Dublin Airport North Runway

Review of EIARs & Additional Information - Noise

0000-BHE-EN-NS-DF-0-EIAR

18 April 2024

Figure 1: From Basner M, Samel A and Isermann U, "Aircraft noise effects on sleep: Application of the results of a large polysomnographic field study", Journal of Acoustical Society of America, 119 (5), May 2006.

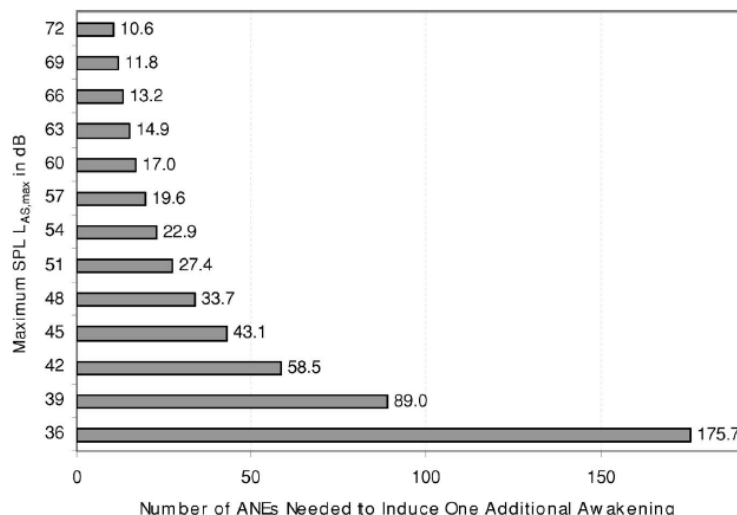
Assessing effects and providing mitigation solely based on the aircraft noise averaged over the whole of the night using the L_{night} noise metric is not considered sufficient in this case, especially as the northern runway would only be used for two one-hour periods at critical times at the start and end of the night. By using the L_{night} metric the ATM noise during these times is averaged over the whole night including 6 of the eight hours of the night when the northern runway would not be in use. Consequently, the likelihood of additional awakening based on the L_{Amax} noise levels of each ATM should be considered as well. This view is based on the *Basner et al* study¹⁰ which established the assessment of additional awakenings based on the L_{Amax} of each ATM. The EIARs both solely use the L_{night} metric to assess %HSD for the RA and the energy averaging inherent in this metric implicitly assumes that the effects of aircraft noise on sleep are simultaneously diminished by 50% if no reduction in the number of ATMs is made but each ATM is 3 dBA less noisy; or the effects of aircraft noise on sleep do not change if the ATMs are all 3 dB less noisy but the number of ATMs doubles. The figure below reproduced from the *Basner et al* study demonstrates this is not true.

The figure above shows, depending on the L_{Amax} of single ATMs, how many ATMs are needed to induce one additional awakening on average, where independent events were assumed. If the maximum L_{Amax} of single ATMs is reduced by 3 dB from, say, 72 to 69 dB, the permitted number of ATMs inducing one additional awakening may not be doubled but only increased by 11% from 10.6 to 11.8 movements. The allowable change in the number of ATMs following reductions in maximum sound pressure level (SPL) of 3 dB increases continuously from 11% (decrease from 72 to 69 dB) to 97% (decrease from 39 to 36 dB), i.e., the number of ATMs may be nearly doubled only very close to the threshold value of L_{Amax} 33 dB (the lowest level at which any effect can be detected).

Figure 2: Figure 7 from CAA report Survey of Noise Attitudes 2014: Aircraft Noise and Sleep Disturbance, Further Analysis CAP2251

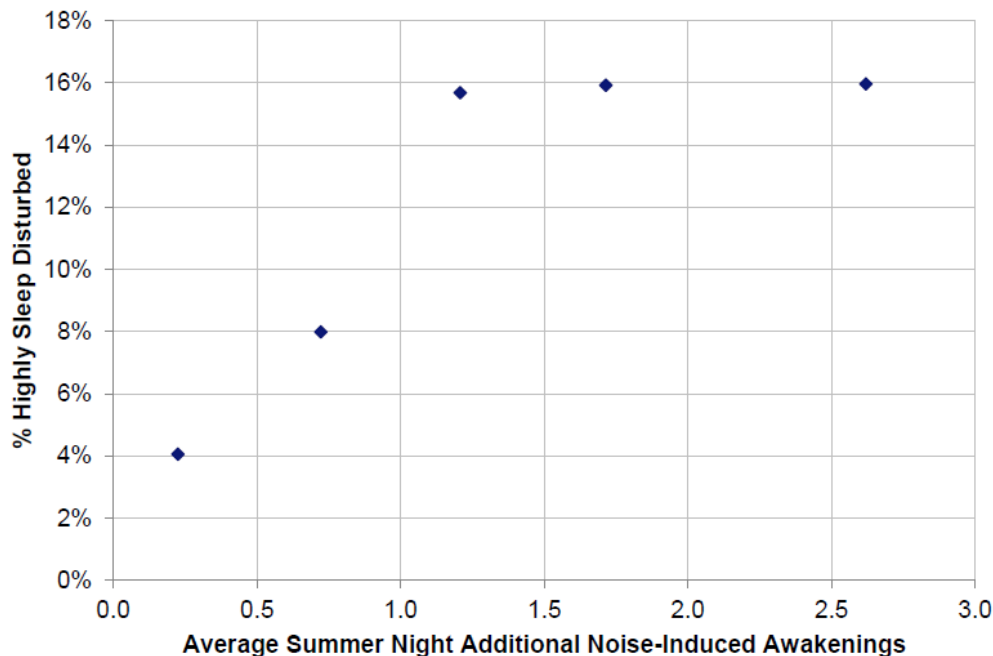
The CAA report Survey of Noise Attitudes 2014: Aircraft Noise and Sleep Disturbance, Further Analysis CAP 2251 (2022) shows a sharp rise in the proportion of residents surveyed stating that their sleep was highly disturbed which coincides with the objective of less than one additional awakening induced by aircraft noise (Figure 7 from the report showing this is reproduced below).

The recent CAA study also reports that one additional aircraft noise-induced awakening is associated with 10% of respondents being highly sleep disturbed. Two and three additional aircraft noise-induced awakenings per average summer night are associated with 15% and just over 20% of respondents being highly sleep disturbed respectively.

Annual Night Quota for 8h equivalent Night Quota Period

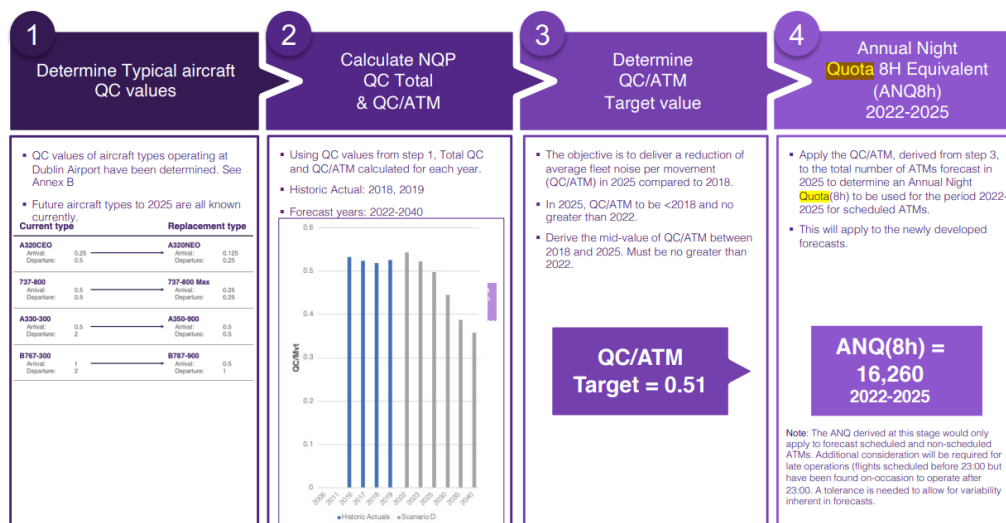
As discussed above, the original proposal was for the QC scheme to apply to only between 2330 and 0600 hrs. However, in response to the request from ANCA to extend the QC to the whole of the night from 2300 to 0700 hrs in the document ANCA: Further information request: Appendix A: Dublin Airport Night Quota System Proposal – DRAFT RFI Update, the DAA Calculated an 8h equivalent Annual Noise Quota and the proposed 16,260 NQ budget was introduced, as shown in the extracts below.

A QC budget of 16260 with an average QC to ATM ratio of 0.51 is equivalent to around 87 ATMs per night i.e. a QC budget of 16260 multiplied by a QC/ATM ratio of 0.51 divided by 365 days a year = 87.3 ATMS

Under a QC system the exchange of several aircraft in a QC band for twice as many in the QC band below or even four times as many in the QC band below that, means the overall QC limit is not breached. Consequently, an assessment of potential difference in % Highly Sleep Disturbed would not indicate any change, as the overall energy averaged L_{night} level would not be altered. However, there is a substantial increase in the number of only marginally to moderately less noisy ATMs, which is likely to lead to an increase in Additional Awakenings¹⁹ based on the L_{Amax} of each ATM and the number of ATMs, as this method is more sensitive to changes in the number of intermittent noise events. Consequently, a QC system is best used in conjunction with an overall cap on the number of flights, as for example at Heathrow, Stansted and Gatwick airports.

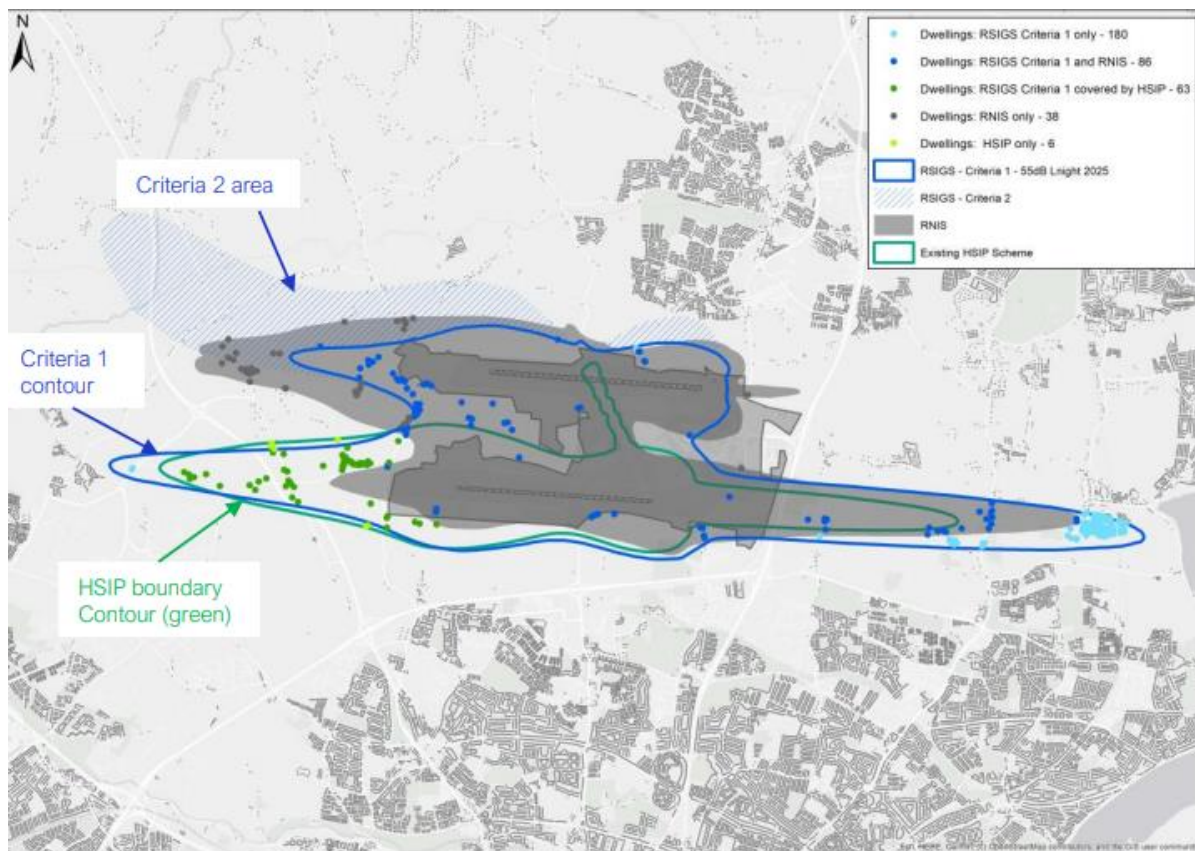
The TPA response only quotes one of the qualifying criteria for noise insulation i.e. Dwellings forecast to be exposed to “high” night-time noise levels in 2025 – of at least 55 dB L_{night} . However, the proposed scheme has two qualifying thresholds and if either is met properties will be offered noise insulation e.g.

- Criteria 1: Dwellings forecast to be exposed to “high” night-time noise levels in 2025 - at least 55dB L_{night} (dark blue contour line in figure below);

- Criteria 2: Dwellings with a “very significant” rating arising from forecast noise levels of at least 50dB L_{night} and a change of at least +9dB in the first full year when the Relevant Action comes into operation when compared with the permitted operation in the same equivalent year (area indicated by blue hatch area in the figure below)

The figure below shows where these criteria apply and how they interact with existing RNIS and HSIP schemes that provide noise insulation based on daytime noise criteria. There has been some minor amendment to the scheme but the figure below provides a reasonable indication of how the existing and proposed noise insulations schemes will interrelate.

As the figure above shows there is some overlap between the schemes, but the proposed RSIGS brings substantial numbers of properties that are not currently eligible into the scheme e.g. to the north west of the airport (Blue Hatching) and in Drumnigh to the east of the southern runway (light blue dots - albeit these properties are relatively recently constructed and planning permission should have ensured that they incorporated noise insulation measures in their design and construction as per FCC planning policy). This means the overall area and number of properties covered by the proposed scheme should the RA go ahead are larger than the existing HSIP programme.
